# IMPORTANT HD//, EX//, TE// and VFX// UPDATES

Updates to the HD//, EX//, TE//, VFX// plows are outlined below. These improvements reflect distributor and end user feedback from the 2017/2018 snow season. All plows shipped from 2018/2019 preseason on will incorporate these updates.

## TECHNICAL SERVICE BULLETIN

<b>NUMBER</b>	<b>16TSB-76</b>			<b>TYPE</b>	<b>SERVICE ALERT</b>			
<b>ROUTING</b>	INSTALL	<b>X</b>	SERVICE	<b>X</b>	SALES	PURCH		
<b>TITLE</b>	<b>G2 LIGHT BAR (UPPER LIFT FRAME)</b>							
<b>REV</b>	<b>B</b>			<b>ISSUED</b>	<b>1/12/2018</b>	<b>REVISED</b>	<b>4/19/2018</b>	
<b>AFFECTS</b>	<b>ALL G2 PLOWS, 1601X002/1601X022, 16111634 LIGHT BAR SOLD IN 2017</b>							
<b>INFORMATION</b>	<p>There have been several instances of the upper light bar (16111634) breaking where it enters the lower lift frame. This can be caused by the fasteners not being properly tightened, or by weld interference preventing them from being properly tightened.</p> <div style="display: flex; justify-content: space-around; align-items: center;">   </div>							
<b>CORRECTION</b>	<p>Inspect the light bars for looseness or damage. A service kit 3038761 has been developed to reinforce existing light b

## What's changed for 2018?

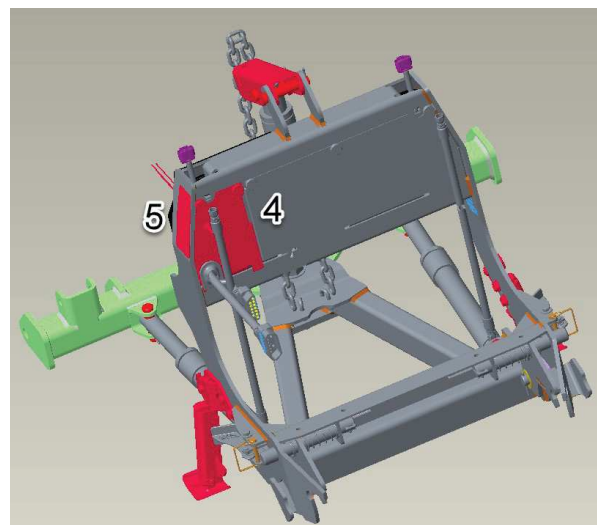
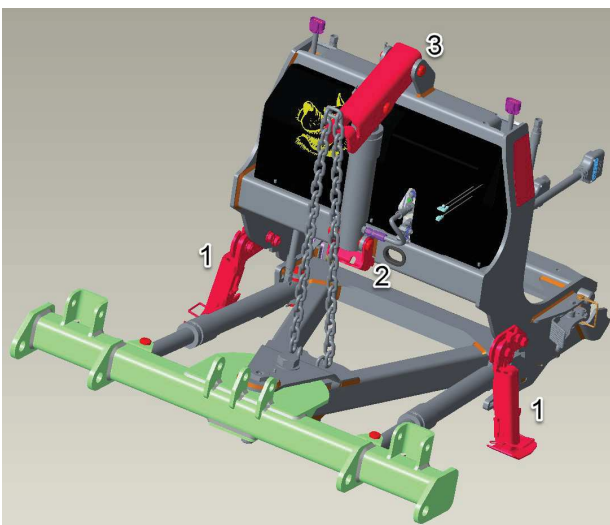
1. Easier to use Prop Feet - designed for use with updated QuickMount II
2. New Stacking Stop - allow maximum stacking while preventing damage to the lift cylinder base
3. Improved Chain lift – No chain clips required
4. and 5. Updated QuickMount II and Jack Switch with Instructional Decal – see below
6. Light Bar Reinforced (see 16TSB-76)

The updated QuickMount II allows the lift frame height to be adjusted while the plow is OFF THE TRUCK.

- The ability to raise the plow compensates for soft ground, different truck mount heights, etc. and controls how much the lift frame tilts forward – meaning easier remounting and less potential interference with truck bumper trim, air dams, etc.
- A JACK SWITCH is located on the lift frame so the user doesn't need to return to the truck cab to adjust plow height.

YES - All new components on the 2018 plows are backwards compatible. For convenience two upgrade kits are available. You can just update the mechanical components (3039461) or you can also add the switch kit (3039678).
